Draft **EN 300 403-1** V1.2.1 (1997-04)

**Integrated Services Digital Network (ISDN);  
Digital Subscriber Signalling System No. one (DSS1) protocol;  
Signalling network layer for circuit-mode basic call control;  
Part 1: Protocol specification**

[ITU-T Recommendation Q.931 (1993), modified]

The text of ITU-T Recommendation Q.931 (1993) was approved by ETSI as an EN with agreed modifications as given below.

## Pages 275 to 277, figure H.5/Q.931 (3 sheets)

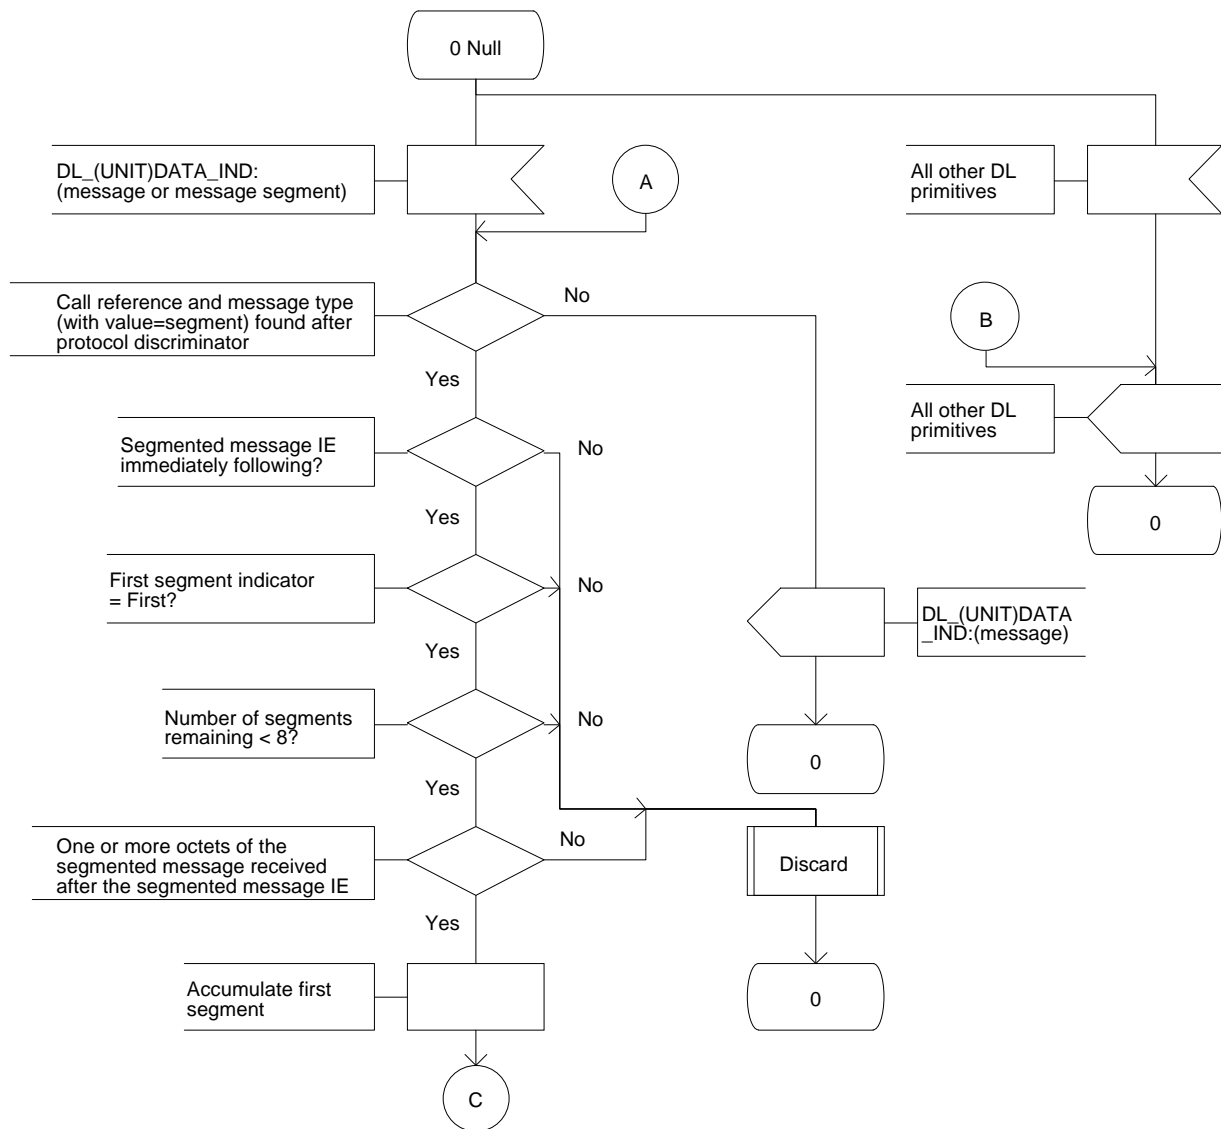
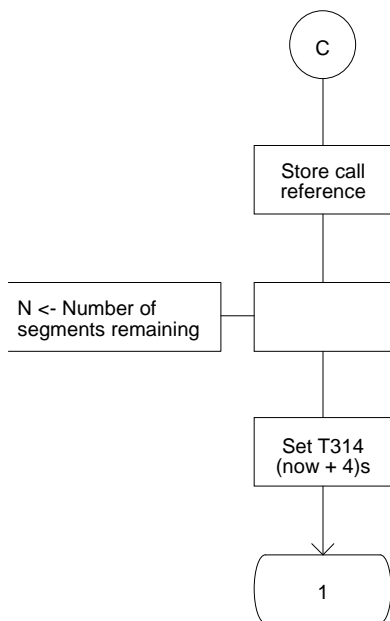
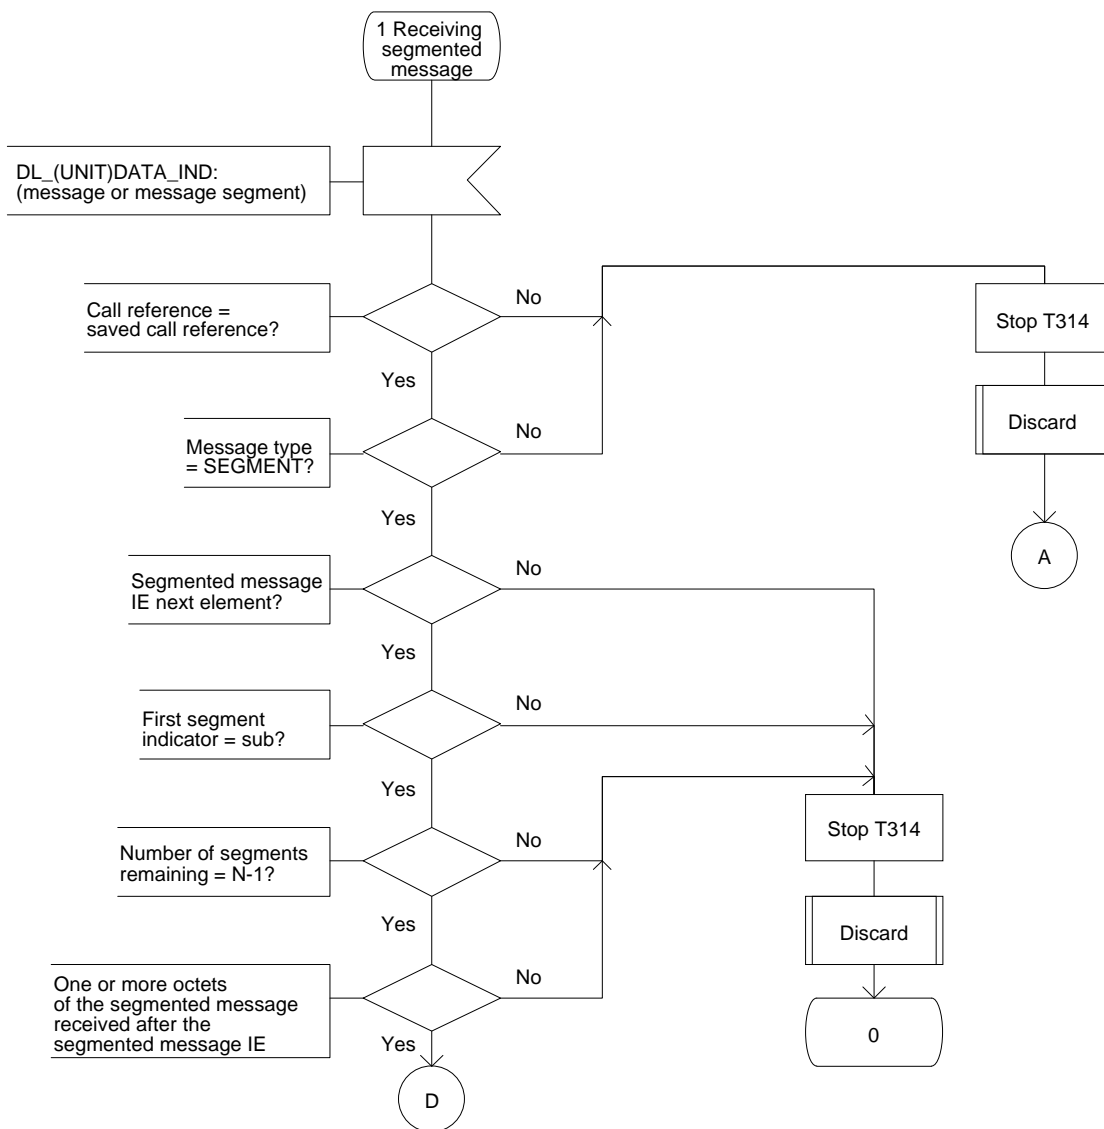
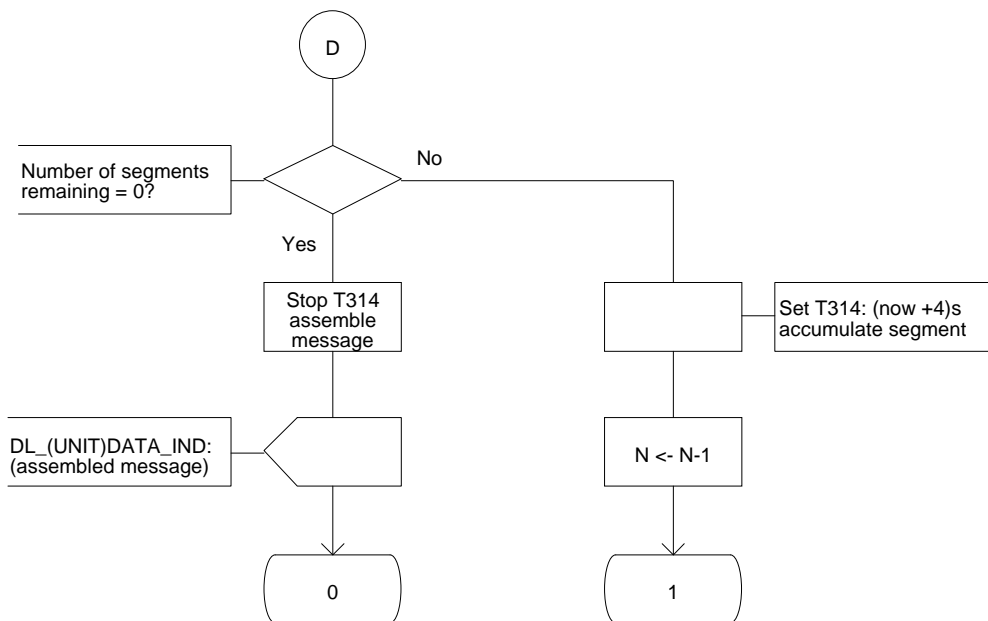
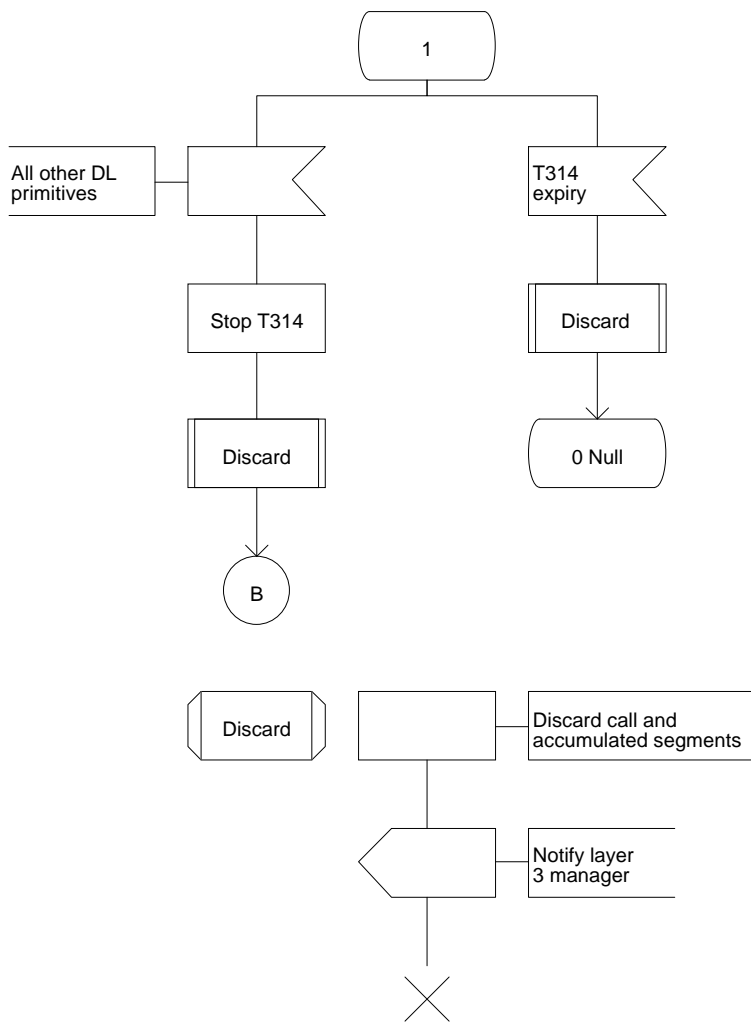
Replace figure H.5/Q.931 (3 sheets) by the following figure (5 sheets):
